Victa and A.E.S.L. Airtourer Series Aeroplanes

**AD/VAT/42
Amdt 1**

**Control Column Wagglers P/N 52115 -
Inspection and Modification**

Figure 1

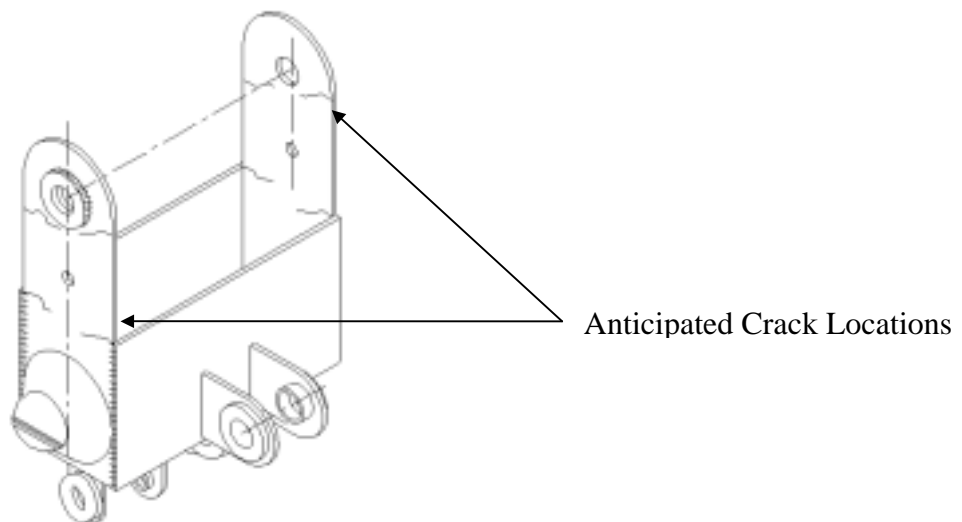
Requirement: 1. Visually inspect both Wagglers attach arms for cracks in accordance with Edge Aviation Service Bulletin EA-AT-2000/001 Issue 1 Section 2. Anticipated crack locations are as indicated at Figure 1.

2. Modify in accordance with Edge Aviation Service Bulletin EA-AT-2000/001 Issue 1 Section 3 or a modification approved by a CAR 35 Authorised Person.

Note: Wagglers modified in accordance with the initial issue of this AD have waggler arms which have been doubled in thickness by the addition of welded doublers to the outer faces of the side attachment arms. Total thickness of the side attachment arms of modified wagglers should be approximately 0.098" (2.49mm). Wagglers so modified meet requirement 2 of this AD.
